# Field Report

**The Park Danforth** **Project No:** 13-059-00  
**Portland ME** **Field Report No:** 19

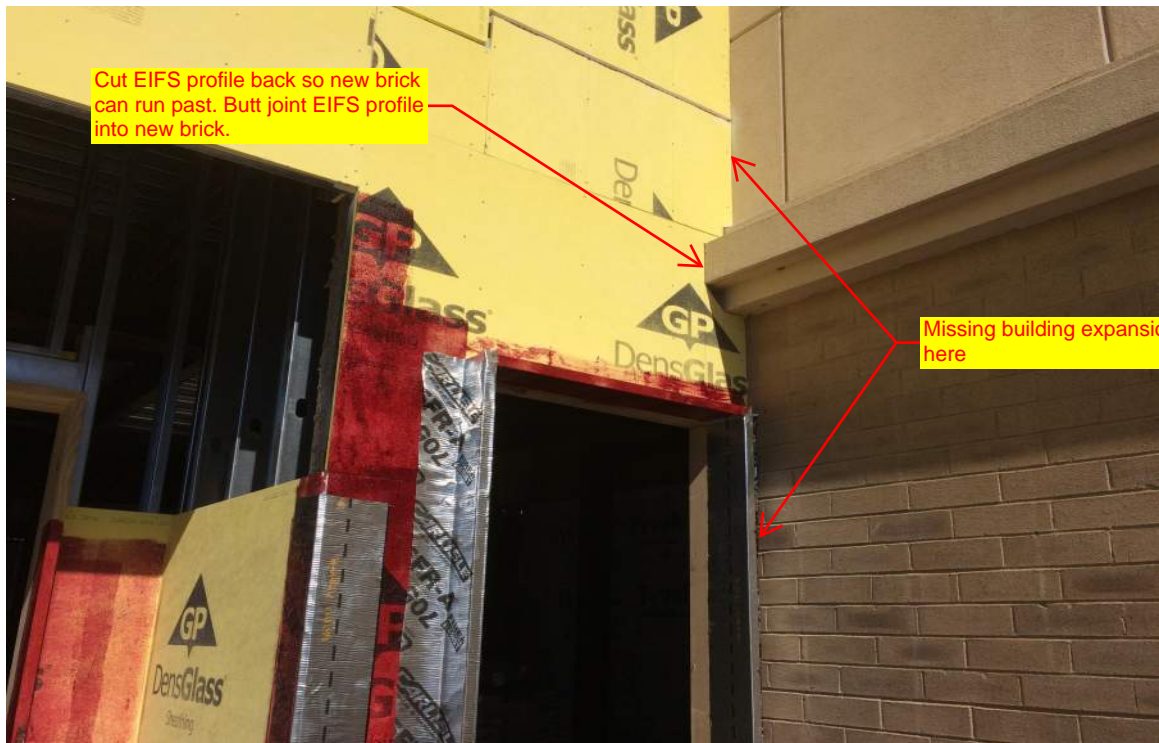
Item	Description	Status:
19.3	<b>Existing EIFS to new Connector Interface</b>  Remove all existing EIFS as required for all new roof tie-ins. All new roof tie-ins shall be flashed back to existing exterior sheathing. Remove existing EIFS in Stair Exit 153-A, and from all other interior spaces. Reference Photo 9B	Correct Work
19.4	<b>Auditorium - Existing Stair Expansion Joint</b>  Construction of the joint between the new auditorium and existing stairwell is lacking an expansion joint as detailed in the Drawings. Reference Photo 10A.	Correct Work
